8 February 2021

**Re: Independent Flooding Assessment  
SSD 10416: Powerhouse Parramatta  
Review of Flooding Aspects**

To	WMA DPIE	4 February 2021
Copies	Tom Kennedy	Reference number 273467
From	ARUP	File reference Tech Note 3001
Subject	Powerhouse Parramatta – Undercroft Loss Factors and Afflux with Fixed Screen

Post-development - River Flood  
Fixed Grill & Fully Blocked  
Afflux  
1% AEP (540 min)

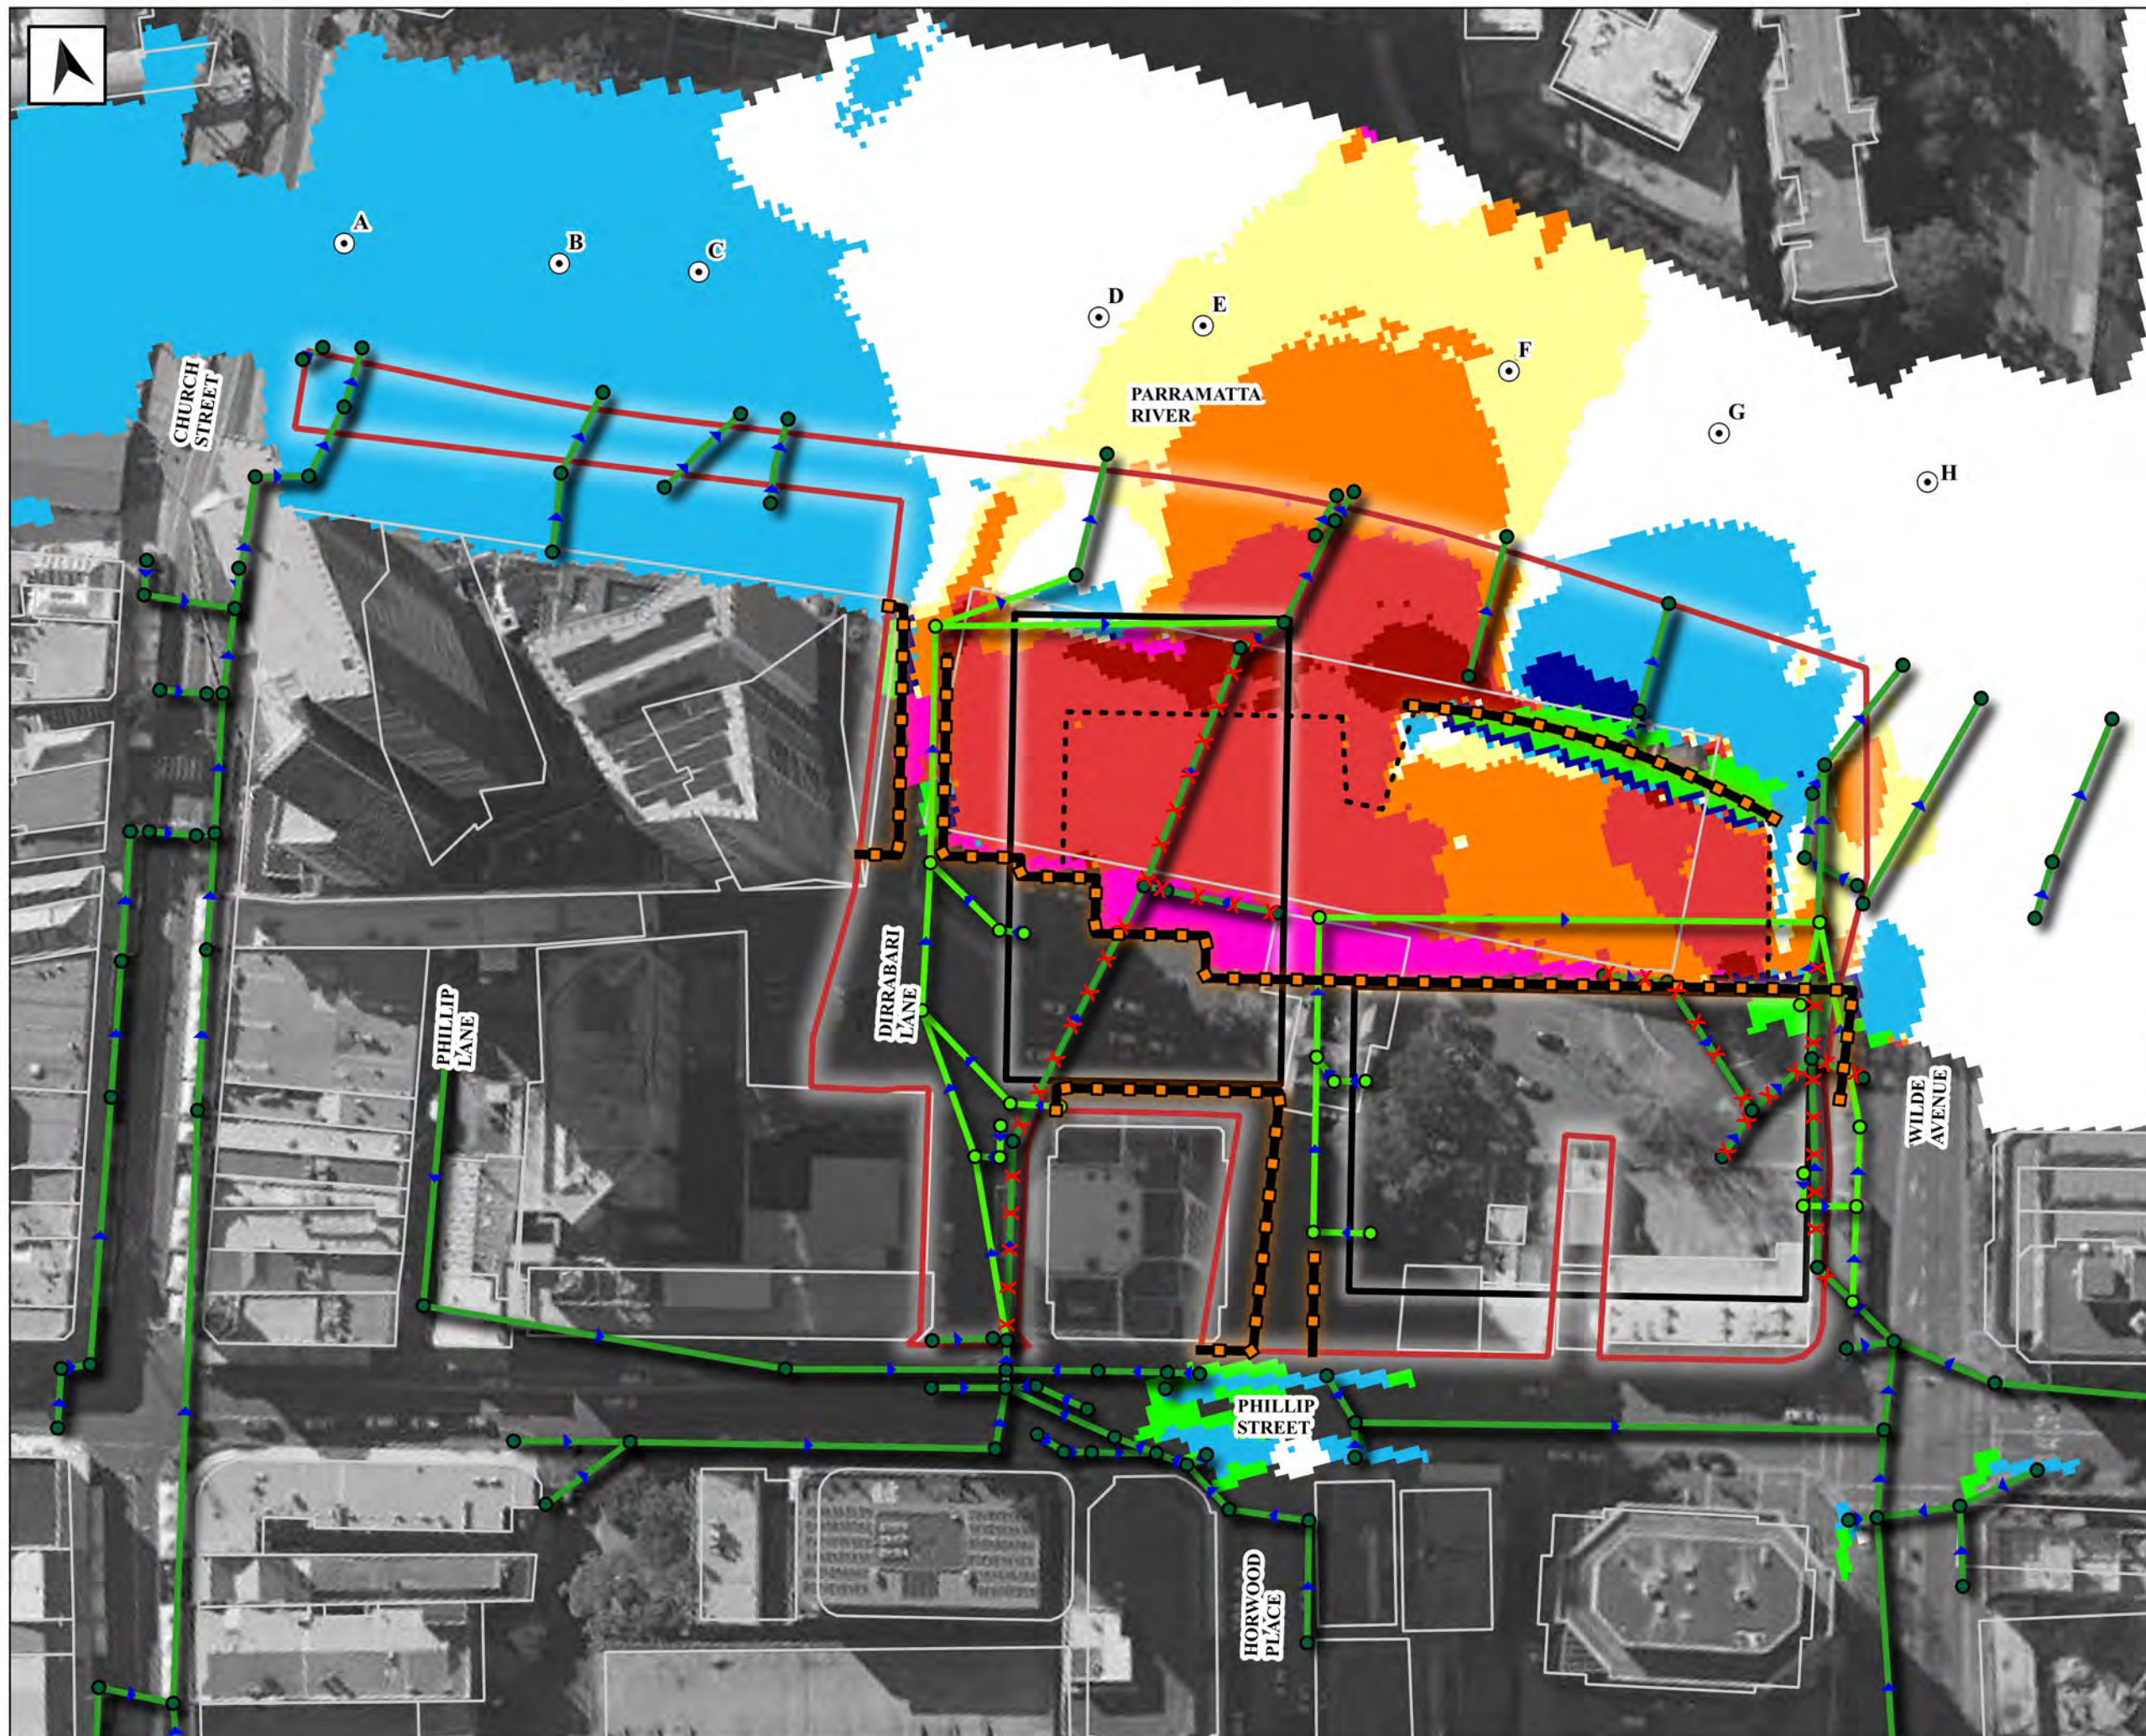
The flood afflux maps for this fully blocked screen scenario are presented as Drawings 3 and 6 for the 1% AEP and 5% AEP flood events respectively.

This afflux map indicates that there would be afflux of up to 70mm in the river and on the properties adjoining the river.
